Replies to First Reviewer

Replies to Second Reviewer

In the present addendum, we propose a simple analytical model to explain the origin of global wind farm blockage. The model uses a perturbation analysis applied to the depth-averaged linearized Navier-Stokes equations, similarly to what previously done by Allaerts and Meyers (2019); Smith (1980, 2007, 2010). In particular, we assume an infinitely wide wind farm in the spanwise direction, so that quantities can only change along the streamwise direction, i.e. $\partial/\partial y = 0$. Furthermore, the background flow, is assumed to have null spanwise component $V = 0$ (this means that Coriolis forcing is neglected). The structure of the potential temperature profile is proper of a conventionally neutral boundary layer (CNBL). This is characterized by a neutral stratification until a strong inversion layer, located at H is reached. For simplicity, this is modeled as a discontinuity in potential temperature, characterized by a jump $\Delta\theta$ located at H , followed by a stable lapse rate γ aloft. The bulk velocity within the boundary layer and the geostrophic wind are referred to as U and U_g respectively. Similarly to Allae

Figure 1. Perturbation velocities, vertical displacement of the pliant surface located at H and perturbation pressure for (a) subcritical case, (b) supercritical case, (c) rigid lid case and (d) fully neutral case. Vertical dashed lines indicate the wind farm start and end coordinates.

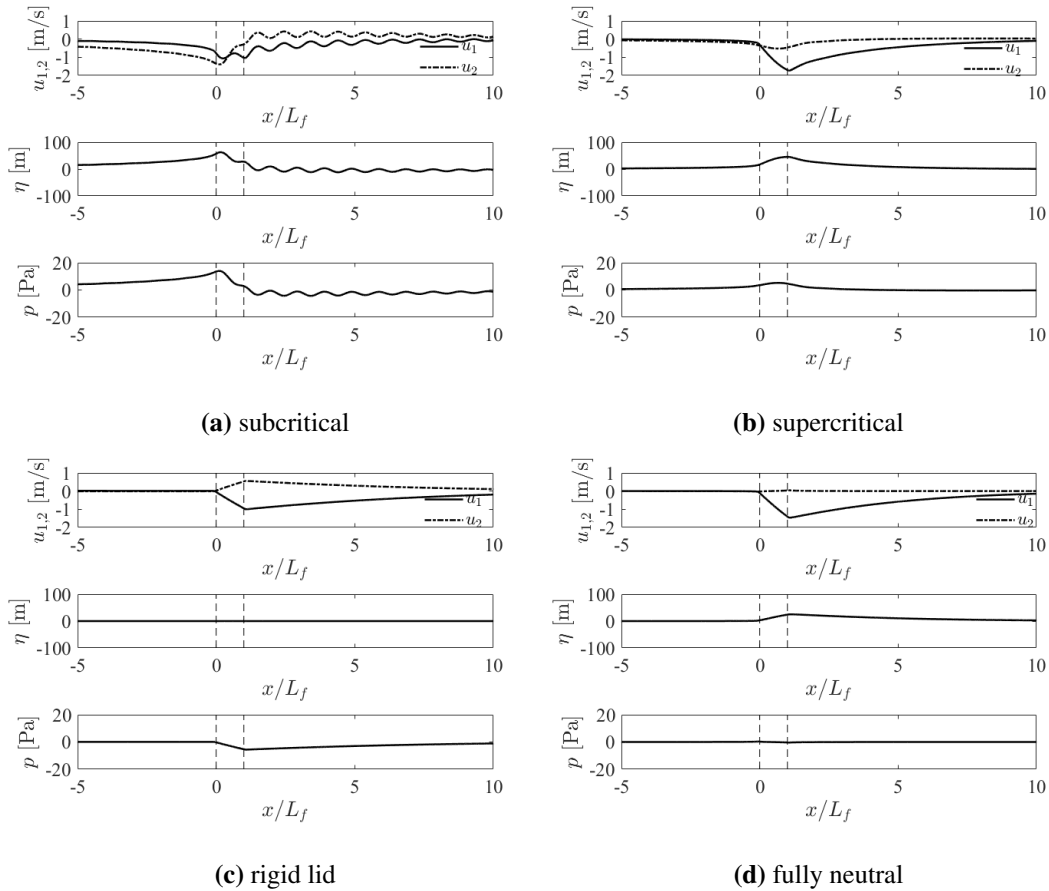
REF: Line 407 – The question is if the plant induced gravity waves are a numerical artifact or they are real.

AUT: We believe the observed gravity waves are consistent with what is published on the characteristics of gravity waves in literature. Their amplitude is dependent on the disturbance and on stratification, and their scale (in terms of wavelength) is extremely large and also depends on stratification. All this has theoretical and mathematical support (Gill 1982, Nappo 2012, Lin 2007, Smith 1980, 2007, 2010, Allaerts and Meyers 2018, 2019, Lanzilao and Meyers 2022a,b,2023).

We included an addendum that clarifies such concept through a simple but insightful model.

As can be seen, wind farm interaction with the stratified atmosphere cannot be fully understood without considering the atmosphere response to the applied wind farm thrust. These simple but yet insightful model, together with plenty previous research work, proves that wind farms do trigger gravity waves by initiating a momentum imbalance, if the free atmosphere is stratified. Additionally, surface waves are also produced by the presence of the inversion layer.
